NOTICE TO POTENTIAL PROPONENTS

ADDENDUM 3 – East Coulee Phase 1 & 2

RFT#2023-02-16

DRUMHELLER RESILIENCY & FLOOD MITIGATION OFFICE		
RESILIENCY AND FLOOD MITIGATION PROGRAM		
EAST COULEE BERM PLAN		
Project No.	CW2384	Drawing No.
Group	EAST COULEE	Rev.
		C-131 1

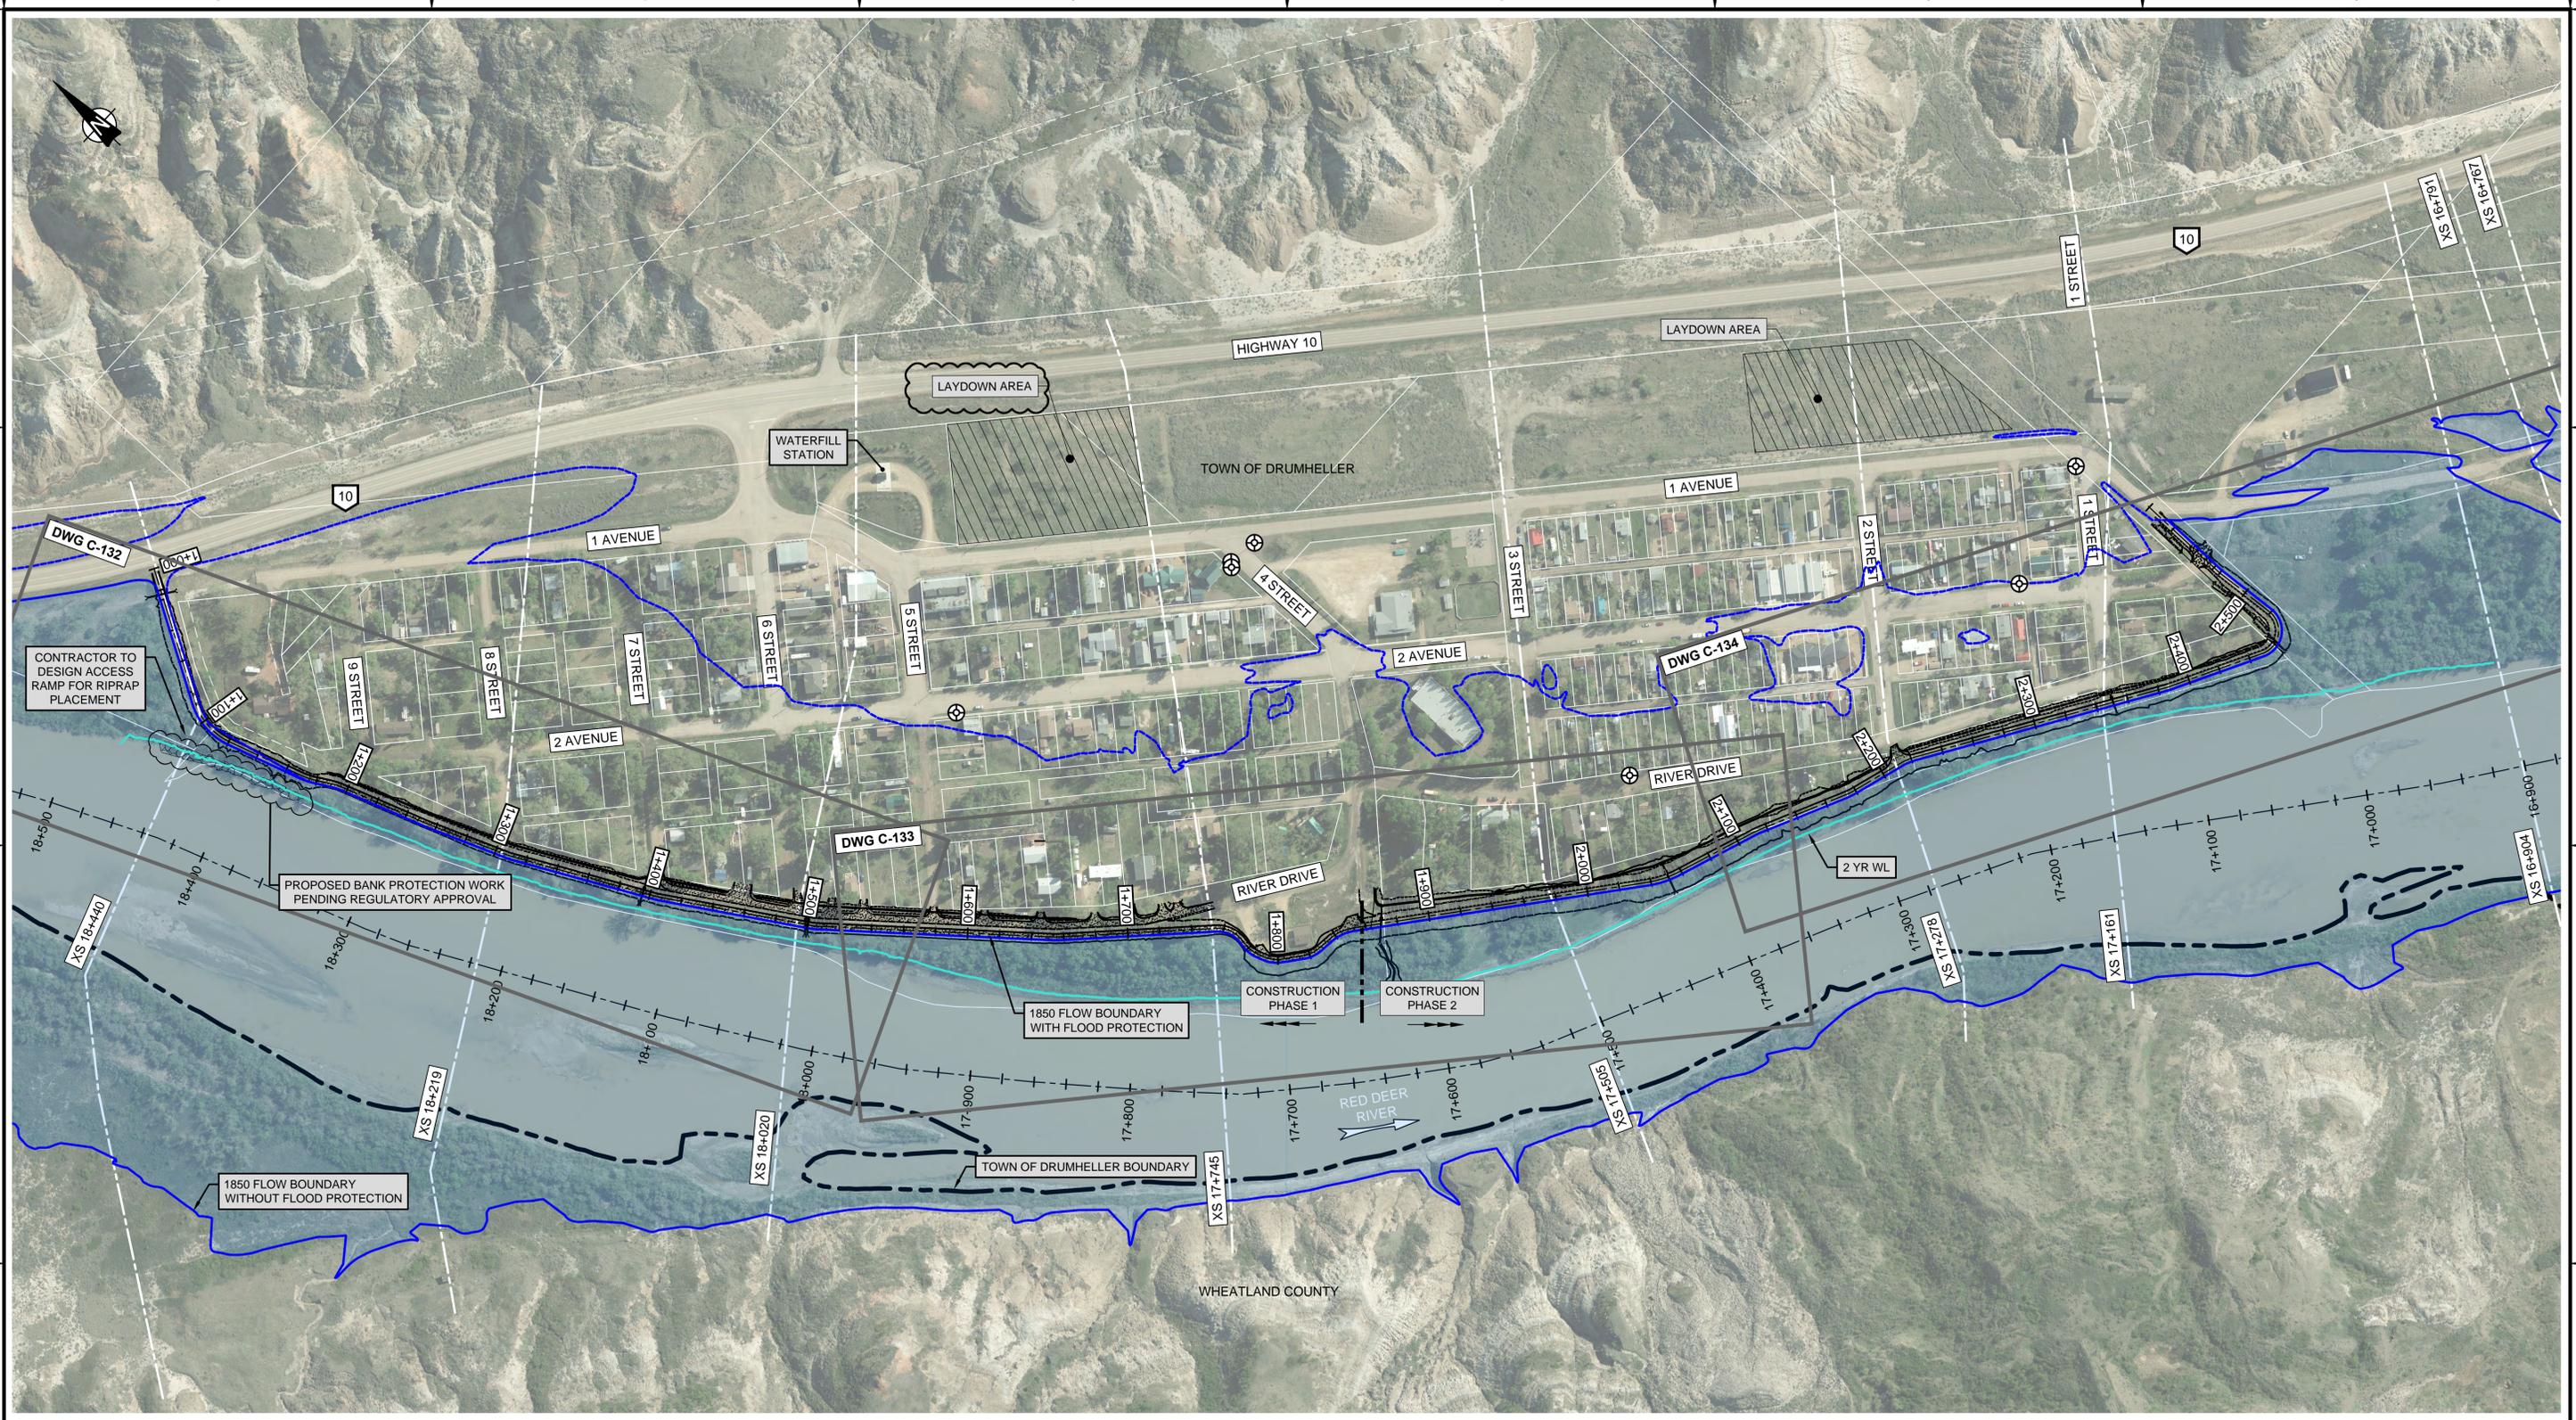
Project Name: RFT - East Coulee Phase 1 & 2 #2023-02-16									
Date: March 27, 2023									
Item	Detail								
A3.1	<p>Clarification on Scope</p> <p>To better clarify the scope of this project, please see the following:</p> <ul style="list-style-type: none"> DWG C-131: "and jersey barrier storage" removed from Laydown area note. As stated in the Tender documents, jersey barriers are to be removed and taken to the Drumheller Public Works Yard (702 Premiere Way, Drumheller). DWG C-137: MH-33 extension on 2 Ave at the downstream edge of Phase 2 added to the drawing. Price Schedule: Phase 2 Item 44 added; Phase 2 Items 44 to 52 advanced 1 to Items 45 to 53. <table border="1" style="width: 100%; border-collapse: collapse; margin-top: 10px;"> <tr> <td style="width: 10%; text-align: center;">44</td> <td style="width: 40%;">5A Concrete Manhole Extension MH33 (0.89 m) – Supply and Install (H.C.S. 2.10) (H.C.S. 5.16) (Special Provisions 4.53)</td> <td style="width: 10%; text-align: center;">1</td> <td style="width: 20%; text-align: center;">Lump Sum</td> <td style="width: 10%; text-align: center;">\$</td> </tr> </table>				44	5A Concrete Manhole Extension MH33 (0.89 m) – Supply and Install (H.C.S. 2.10) (H.C.S. 5.16) (Special Provisions 4.53)	1	Lump Sum	\$
44	5A Concrete Manhole Extension MH33 (0.89 m) – Supply and Install (H.C.S. 2.10) (H.C.S. 5.16) (Special Provisions 4.53)	1	Lump Sum	\$					
A3.2	<p>Clarification on Scope</p> <p>To better clarify the scope of this project, please see the following:</p> <p>Question 1: The Town indicated in the meeting they are open to pre-purchase long lead items in 2023, for 2024 work. Could the borrow clay material for 2024 be hauled and stockpiled in 2023, in order to reduce risks with borrow pits?</p> <p><i>Answer 1: Stockpiling of Borrow Fill, Impervious Fill, and Imported Topsoil will not be allowed over the winter of 2023/2024. Gravels, riprap, pre-cast concrete structures, and culverts can be stockpiled within designated laydown areas over the winter for 2024 work. Contractors shall assume that no additional storage areas outside of designated laydown areas will be provided by the Town.</i></p> <p>Question 2: Can you confirm the suitability and classification testing requirements for the borrow fill? The requirements for testing are laid out in section 4.62, and addendum 1, but the frequencies of tests are not clear.</p> <p><i>Answer 2: Testing outlined in Table 1 of the Updated Parkland Borrow Source Letter provided in Addendum 1 shall be performed at a minimum once per 10,000 m³ of fill per Borrow source prior to</i></p>
